ADDENDUM NO. 2

Project Name: **Roseland Elevated Storage Tank Change and Pump Station**

Bid Number: 2019068

This addendum is being released to answer questions received to date.

SHEET NUMBER
C-4

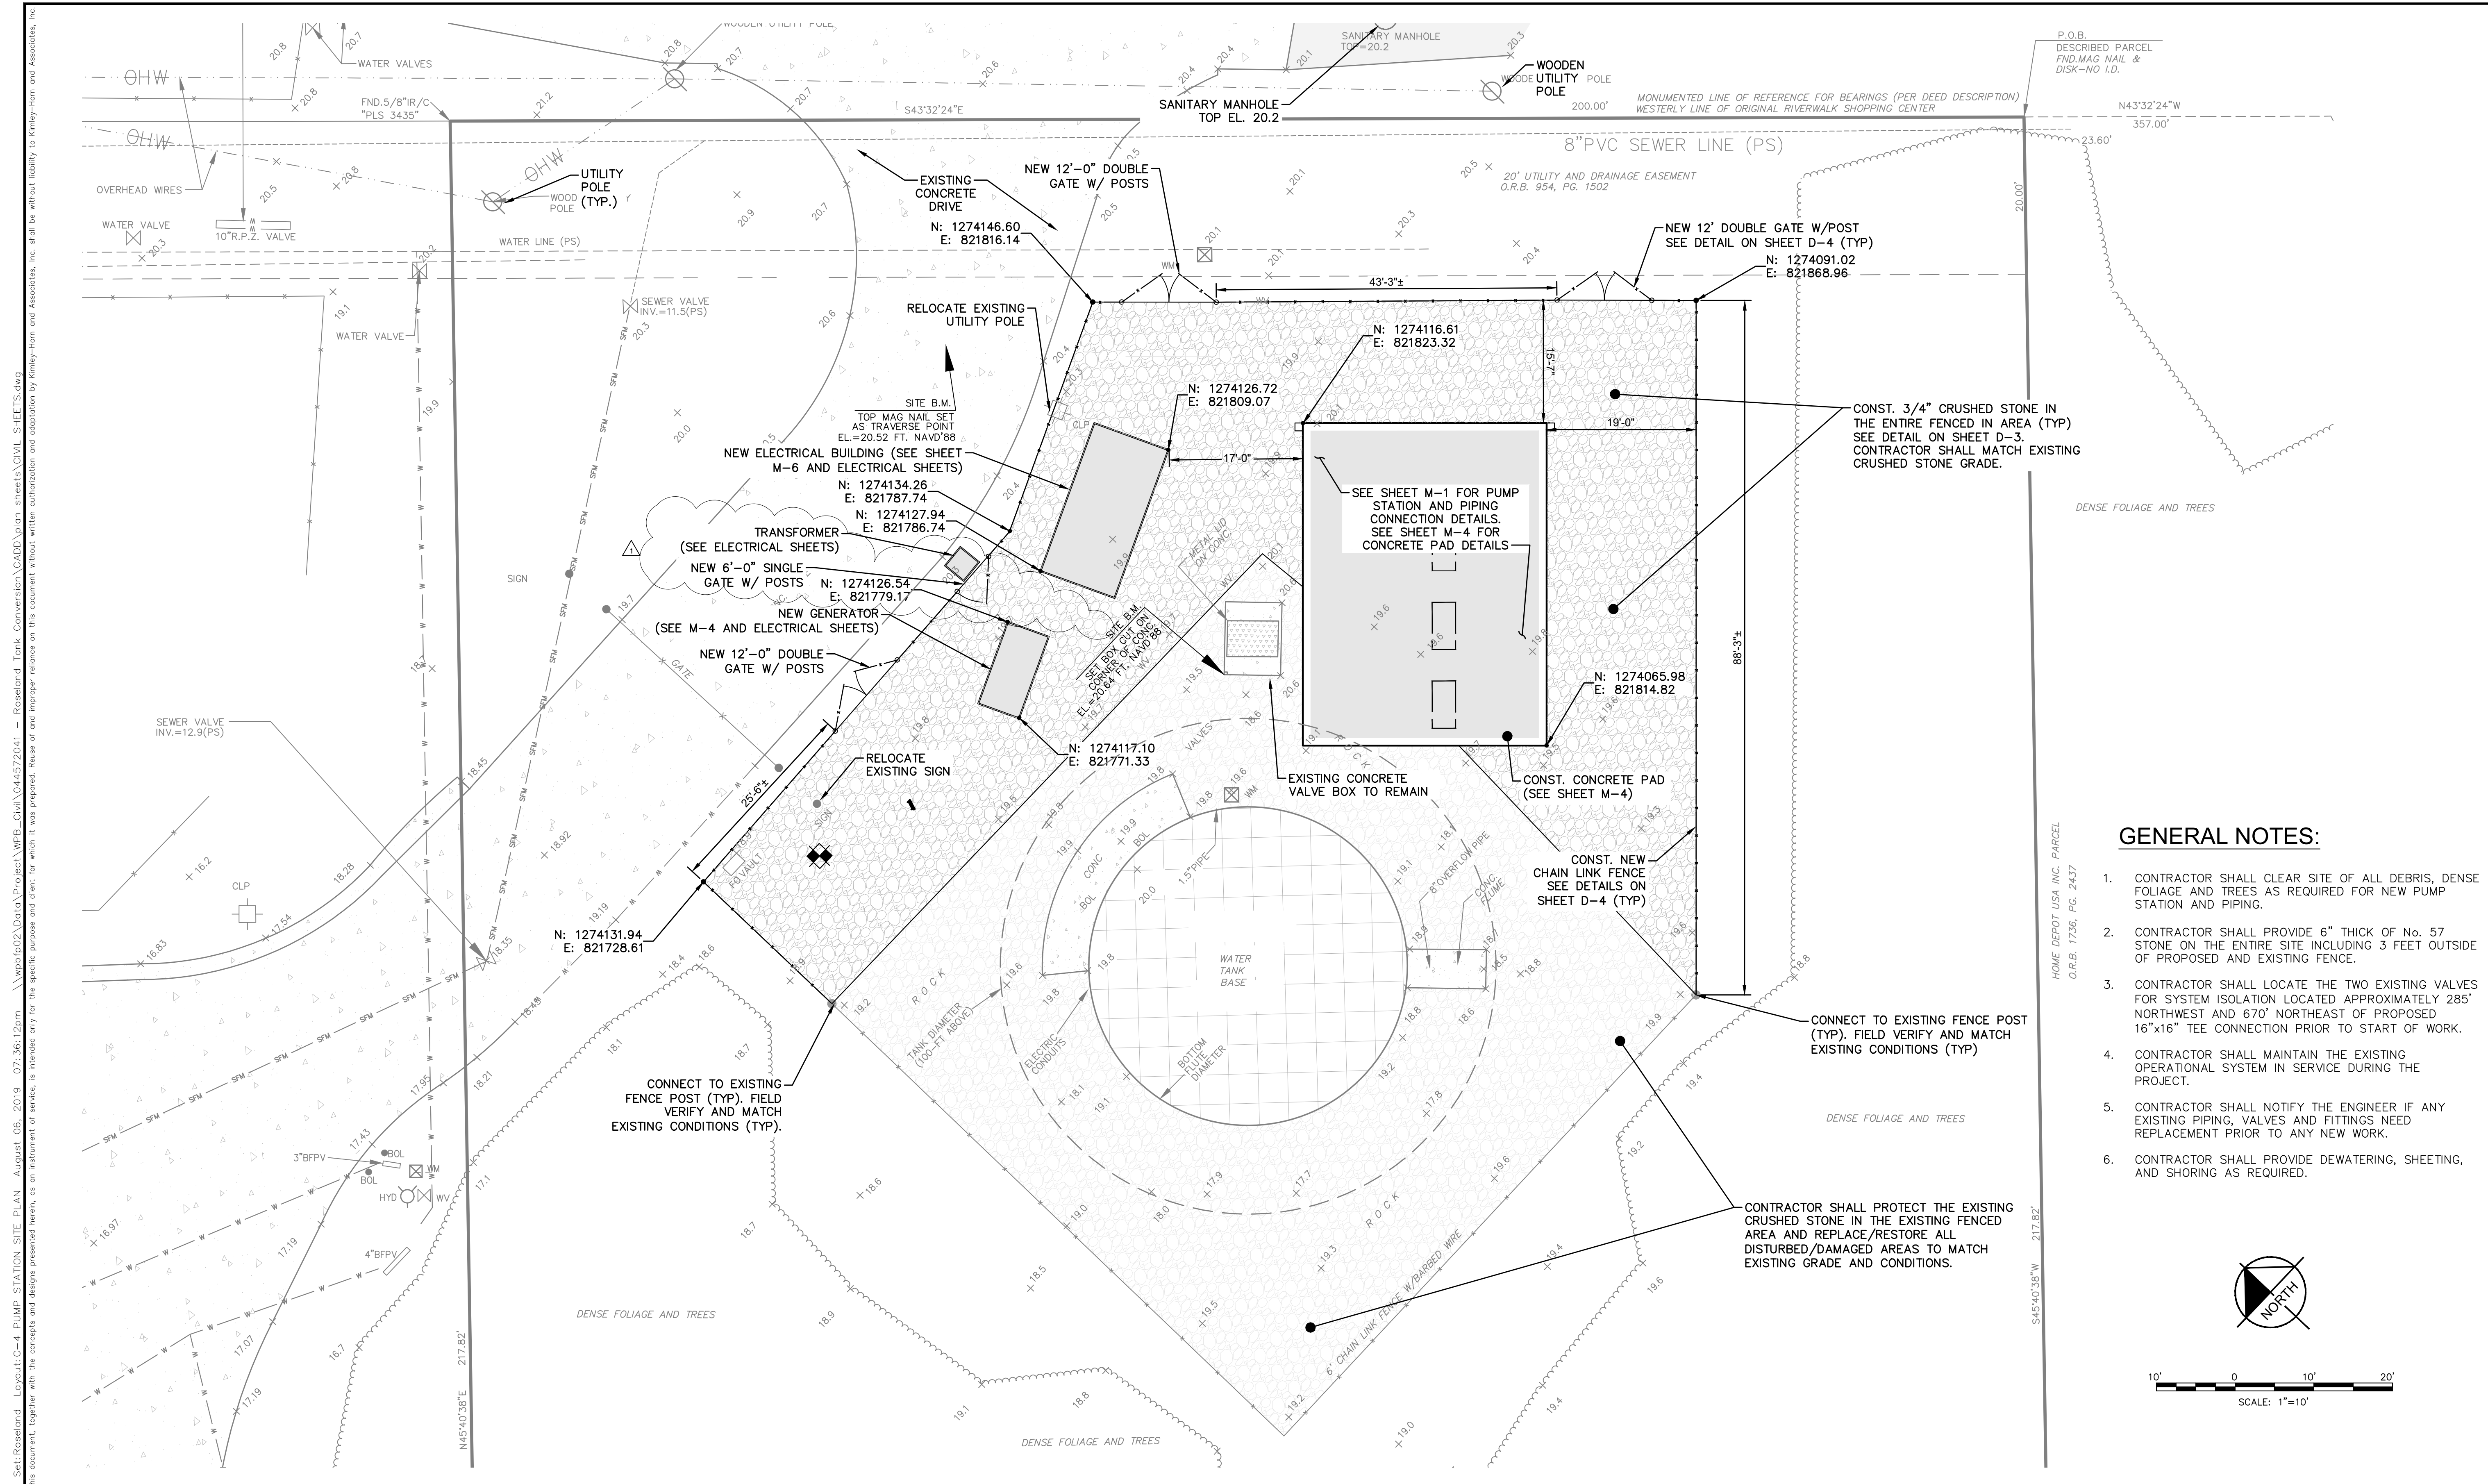
8. **Question:** Sheet C-4 "contractor shall protect the existing crushed stone in the existing fence area" and GN #2 "Contractor shall provide 6" thick of #57 Stone"

- a. is #57stone required in the areas where there is crushed stone?

- b. if the above is yes, can the crushed stone be used as part of the 6" thick layer?

Yes. However, in the areas with existing crushed stone, the Contractor shall use the #57 stone to replace/restore all disturbed/damaged areas to match existing grade and conditions.

The 6" thick of #57 is not required in the areas with existing crushed stone. In the areas with existing crushed stone, the Contractor shall use new #57 stone to replace/restore all disturbed/damaged areas to match existing grade and conditions.

SHEET NUMBER
C-5

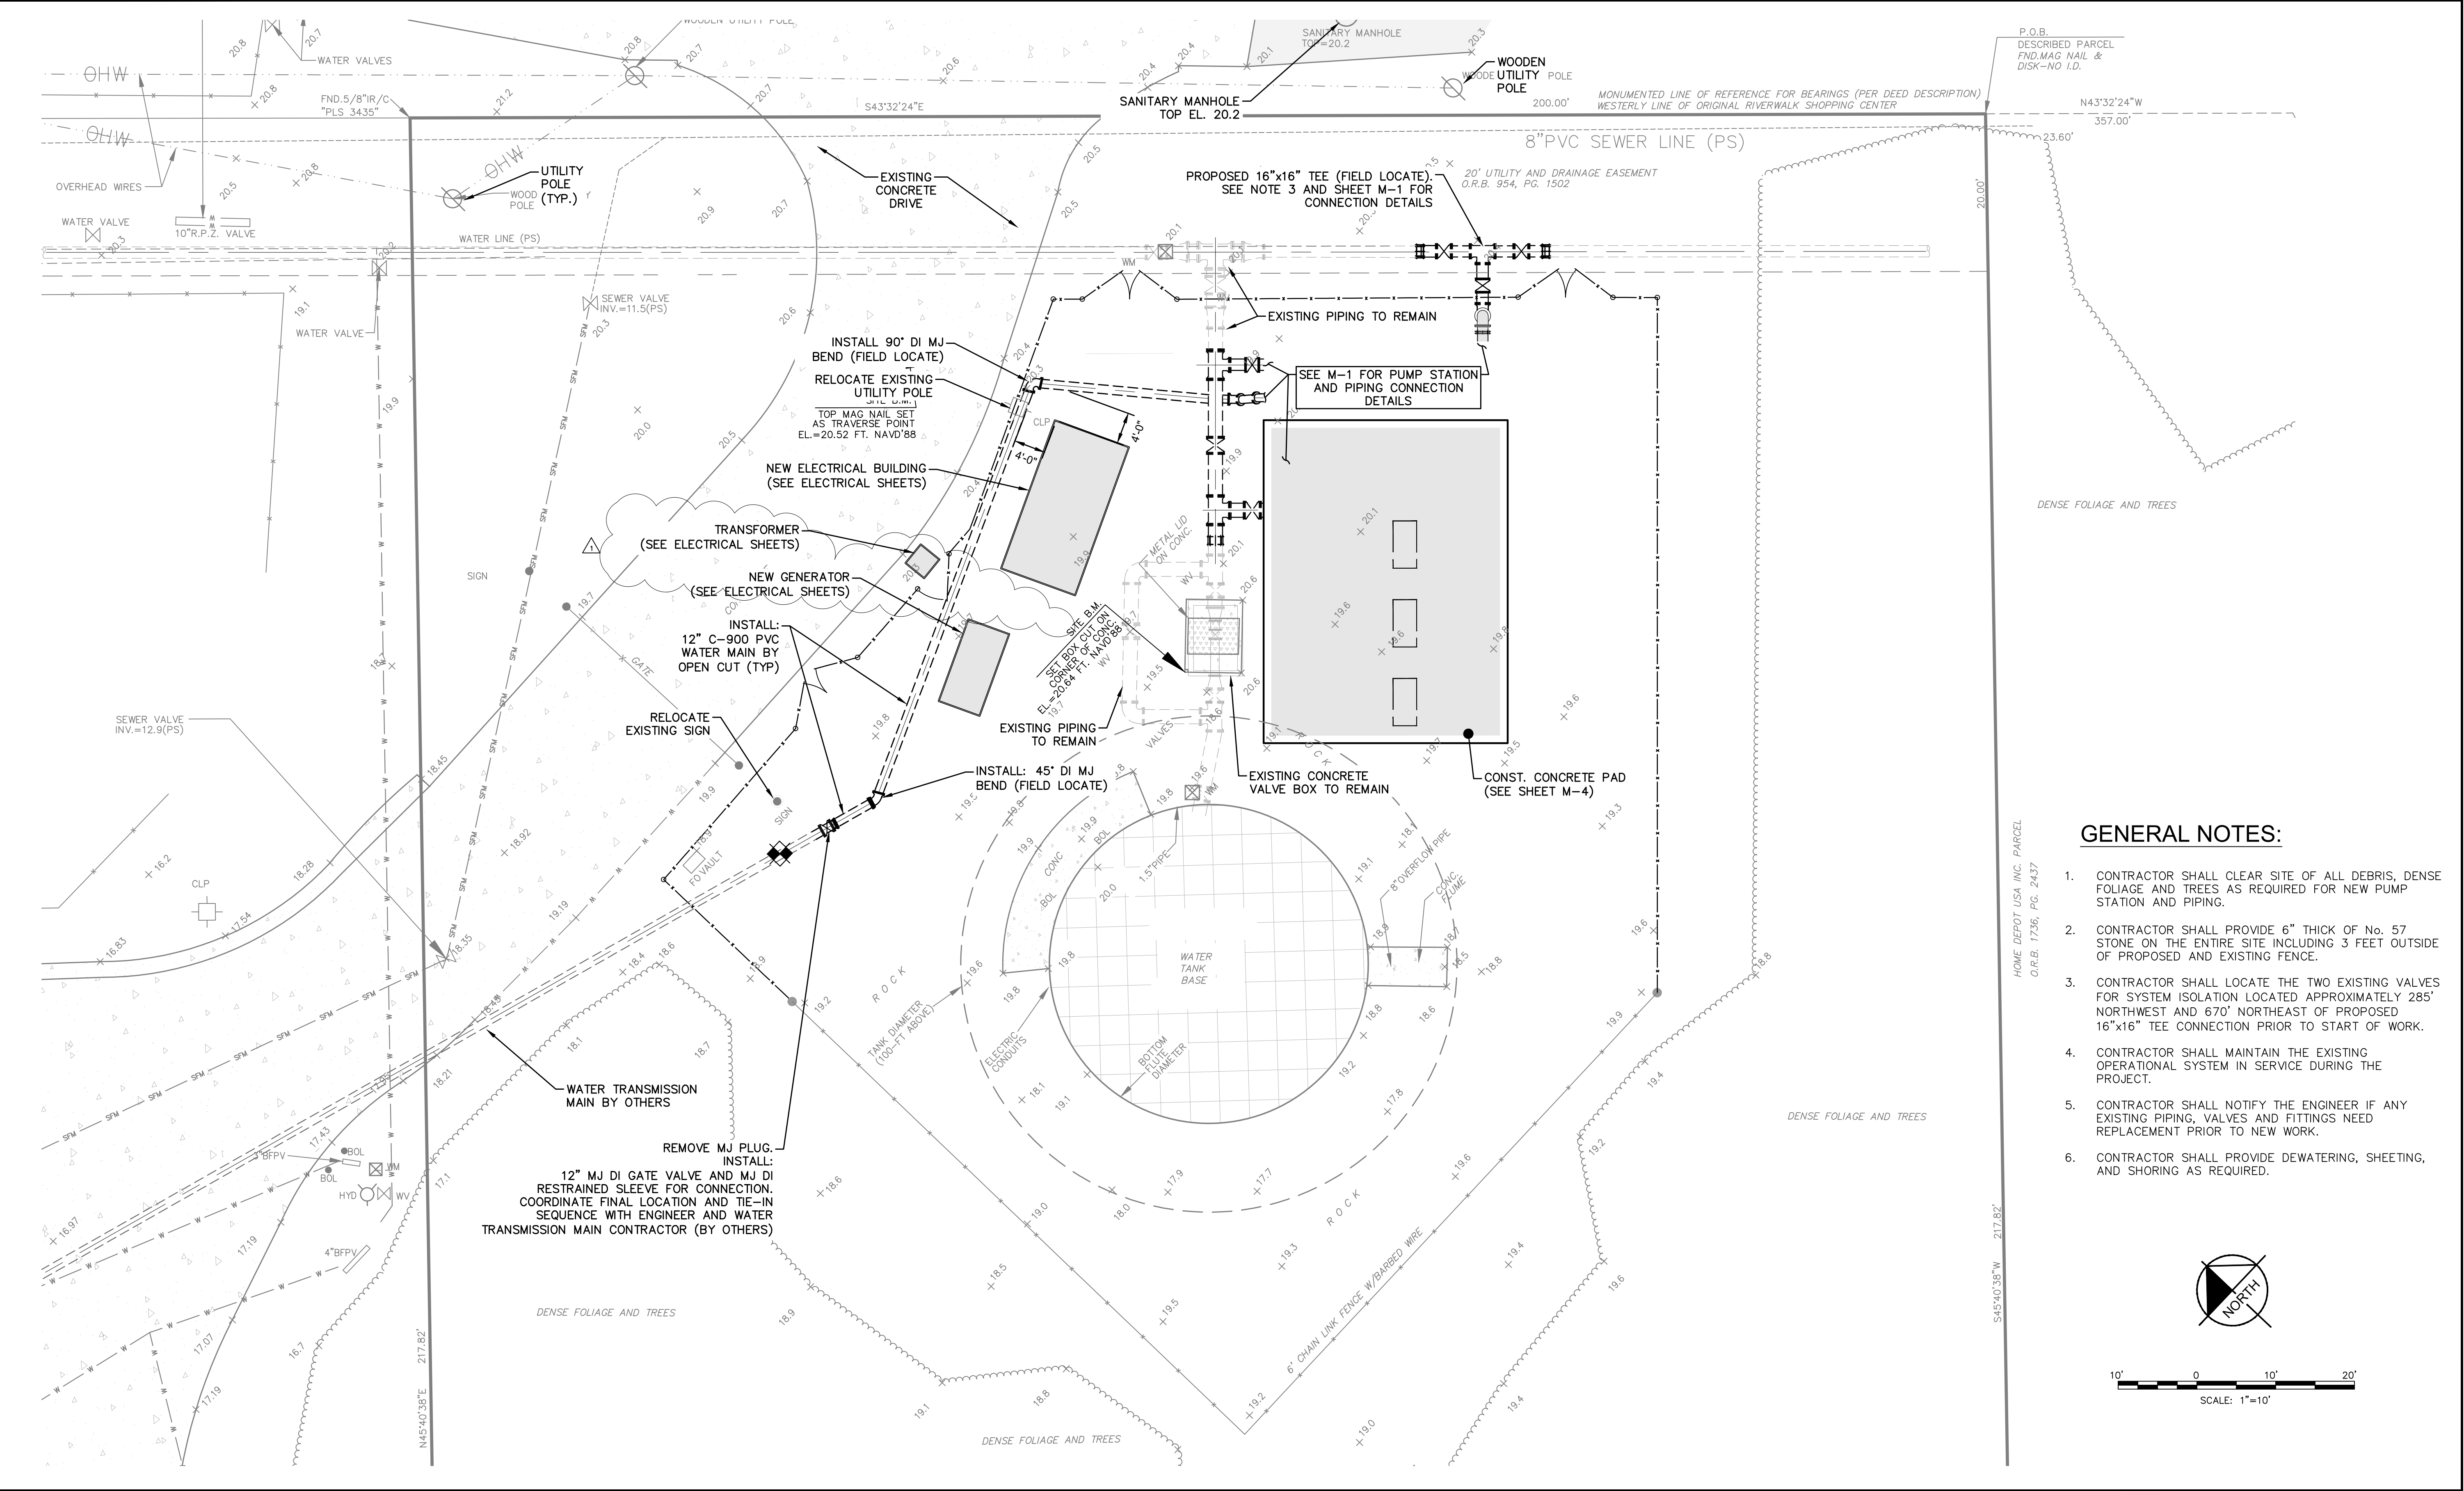
7. **Question:** Sheet C-3 Note 4 contractor shall maintain the existing operational system in service during the project: is a bypass require for the 20" and 16" DIP water pan pipe?

A temporary bypass is not required. Temporary elevated storage tank shutdowns required for the proposed 20" and 16" connection requires 48 hours advance notice and approval from IRCU. See Specification Section 13000, Paragraph 1.02.E. Additionally, see General Note No. 3 on Sheet C-5 for system isolation coordination notes.

Yes, but the Water Transmission Main (furnished by others) as shown on Sheet C-3 and Sheet C-5 is 12” DR-11 HDPE and is not included in the Contractor’s scope of work for this project.
